BRIDGE
INSPECTION
AHEAD

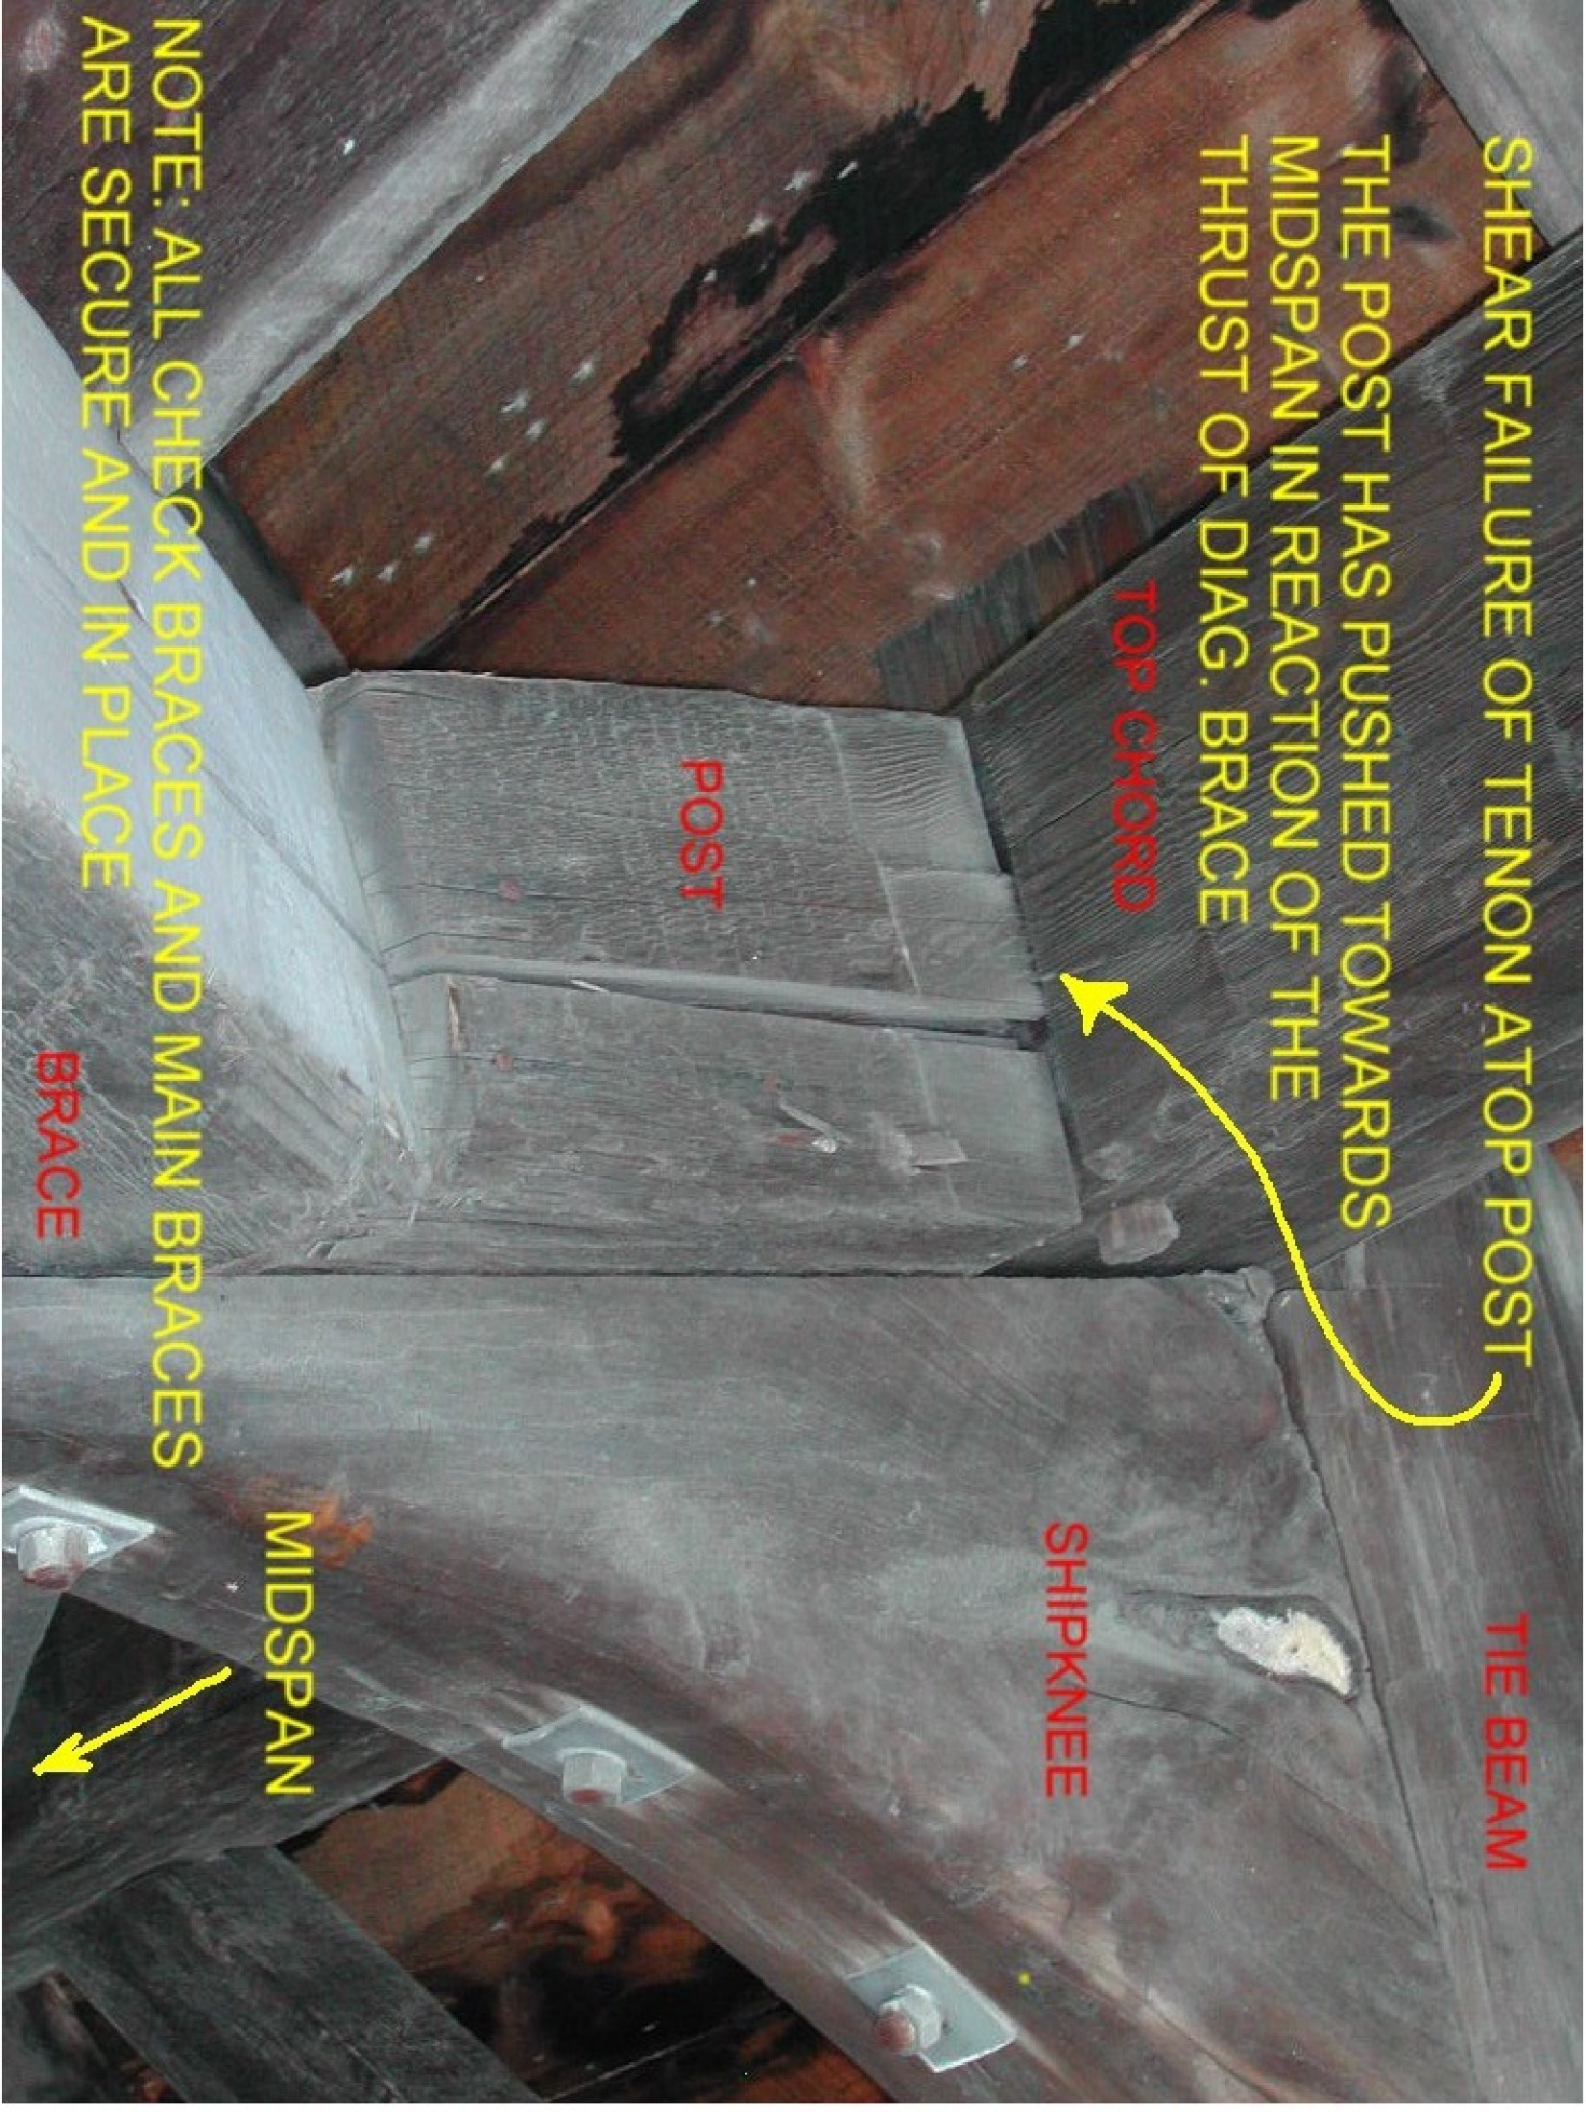
SHEAR FAILURE OF TENON AT TOP POST

THE POST HAS PUSHED TOWARDS
MIDSPAN IN REACTION OF THE
THRUST OF DIAG. BRACE

REPAIR TO OUTER ARCH "RIB"
ALONG DOWNSTREAM SIDE
BETWEEN POSTS 4 AND 6

TYPICAL TENON FAILURE ALONG WITH MINOR
POST DROP AT INTERFACE WITH UPPER
CHORD

NOTE RECENT REMOVAL OF LONGITUDINAL DISTRIBUTION STRINGERS
